APPLICATION NO.	FILING DATE	FIRST NAMED INVENTOR	ATTORNEY DOCKET NO.	CONFIRMATION NO.
10/768,095	02/02/2004	Francois Houde	12214-3US	5766
20988	7590	05/23/2006	EXAMINER	
OGILVY RENAULT LLP 1981 MCGILL COLLEGE AVENUE SUITE 1600 MONTREAL, QC H3A2Y3 CANADA			BANKHEAD, GENE LOUIS	
			ART UNIT	PAPER NUMBER
			3744	
DATE MAILED: 05/23/2006

Office Action Summary	Application No. 10/768,095	Applicant(s) HOUDE, FRANCOIS	
	Examiner Gene L. Bankhead	Art Unit 3744

DETAILED ACTION

Figure 1 (Aston)

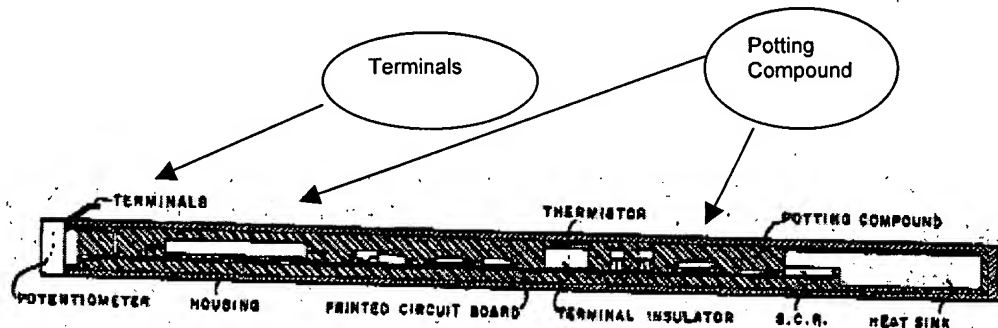
Claims 1-5, 11-14, and 19-21 are rejected under 35 U.S.C. 102(a) as being anticipated by Aston (US 3581602). Aston discloses a room thermostat encompassing a circuit board, with at least one electric relay mounted to the board, with a primary casing (the housing of Figure 1 below) that defines a chamber housing for the circuit board, (see Figure 1 and column 1, lines 68-71).

The chamber of Aston is filled with an insulation material capable of depressing any sound made by the electric relay. See Figure 1.

Regarding claims 3 and 4 Aston teaches a potting compound used as the insulation material is a potting compound, Figure 1. Aston discloses that the insulation material encompasses epoxy and urethane compounds, (column 1, lines 60-67).

With regard to claim 5, the potting compound clearly spans the entire surface of the circuit board. The electric relay is substantially surrounded on all sides by the insulation material (see Figure 1).

Regarding claim 11 Aston further teaches an acoustically electric unit with at least one electromechanical switch (column 1, lines 68-71), surrounded by casing, (see Figure 1). Aston further discloses that the electromechanical switch is completely bedded in the insulation material (column 1 lines 30-35).

Regarding claim 12, the electromechanical switch of Aston is housed in a secondary casing within the primary casing, (column 1 lines 52-60 and Figure 1 above). The electromechanical switch encompasses a "gate controlled rectifier device, such as a thyristor or a silicon controlled rectifier", (column 1 lines 70-75). Thus it is inherent that the switch contains an electromagnet and an armature.

Figure 2 (Aston)

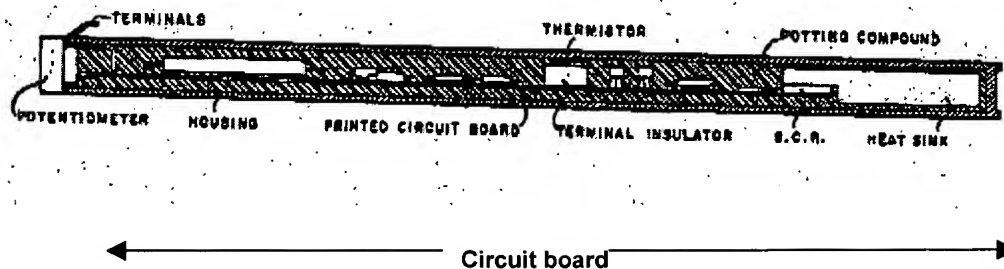
In reference to claims 13 and 14, Aston teaches an insulating material that is a potting compound (see Figure 2 below); encompassing epoxy and urethane compounds (column 1 lines 60-67).

With regard to claims 20 and 21 Aston discloses an electromagnet and armature disposed in a casing (see Figure 2 and column 1 lines 70-75), the casing is filled with potting compound (see Figure 2 above), and the electromechanical switch is enclosed in a secondary switch casing, (column 1 lines 52-60). The switch casing is enclosed in the primary casing, the housing of Figure 2. The thermostat of Aston meets all structural limitations of claims 20

Figure 3 (Noba)

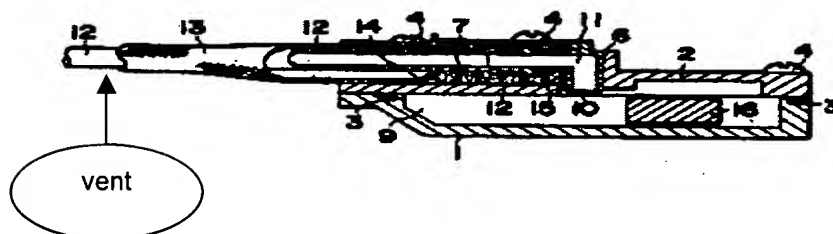
Claim 6 is rejected under 35 U.S.C. 103(a) as being unpatentable over Aston in view of Noba (US 3944774). Claim 6 differs from Aston in calling for a vent in the electric relay capable of venting ionized air. Noba discloses an electric relay with a casing 1, and a vent 12 capable of venting ionized air produced during the relays operation, see Figure 3 below. Noba teaches it is advantageous to be able to conduct air into and from a casing surrounded by insulation. It would have been obvious to one of ordinary skill in the art at the time of the invention provide the thermostat electric relay of Aston with a vent in view of Noba in order to prevent overheating of the relay.

Claim 15 is rejected under 35 U.S.C. 103(a) as being unpatentable over Aston in view of Noba. Aston discloses all limitations of claim 11, however does not disclose a vent for the second casing housing the electric relay. Noba discloses an electric relay with a casing 1, and a vent 12 capable of venting ionized air produced during the relays operation, see Figure 3 above. Noba teaches it is advantageous to be able to conduct air into and from a casing surrounded by insulation. It would have been obvious to one of ordinary skill in the art at the time of the invention provide the thermostat electric relay of Aston with a vent in view of Noba in order to prevent overheating of the relay.

Figure 5 (Moyer)

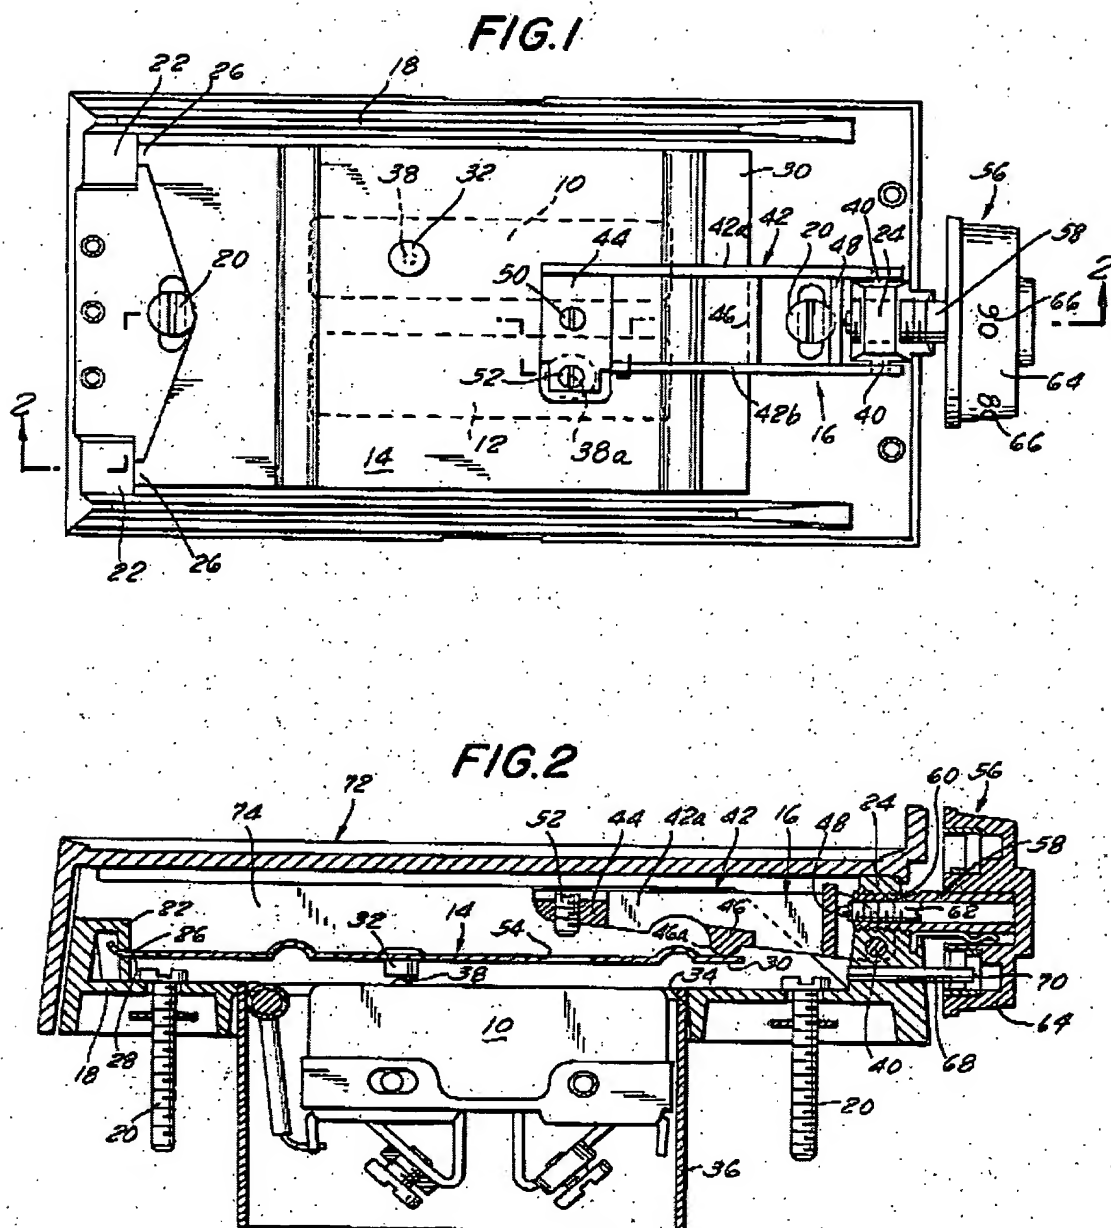
Claims 7-10 are rejected under 35 U.S.C. 103(a) as being unpatentable over Aston in view of Nesbitt (US 6347747) in further view of Noba and Moyer et. al (US 3421131), as applied to claim 6 above. Claim 7 differs from Aston in calling for a male projection received in a corresponding female part to extend axially through a primary casing with a pathway for air from the electric relay to flow. Moyer discloses a thermostat assembly wherein a male projection 20 is received in a corresponding female part 18, with a gasket about the male projection 26 to tighten the base plate 18 and cover 72, see Figure 5 below. Claim 10 differs from Aston in calling for a primary casing with at least one opening for pouring insulation material into the chamber of the thermostat. Nesbitt teaches a casing 1, see Figure 4 below, with vents capable of venting ionized air from the electric relay, and for pouring insulation material into the chamber of the thermostat. Nesbitt teaches it is advantageous for air to flow directly across the temperature sensor surface of thermostat. Therefore it would have been obvious to one of ordinary skill in the art at the time of the invention to modify Aston with Nesbitt, Moyer and Noba in order for the outside ambient air temperature to be detected with greater precision and speed, and to ensure a more rigid connection between the circuit board and base plate, firmly securing the electronic components in the event of mechanical damage to the thermostat.
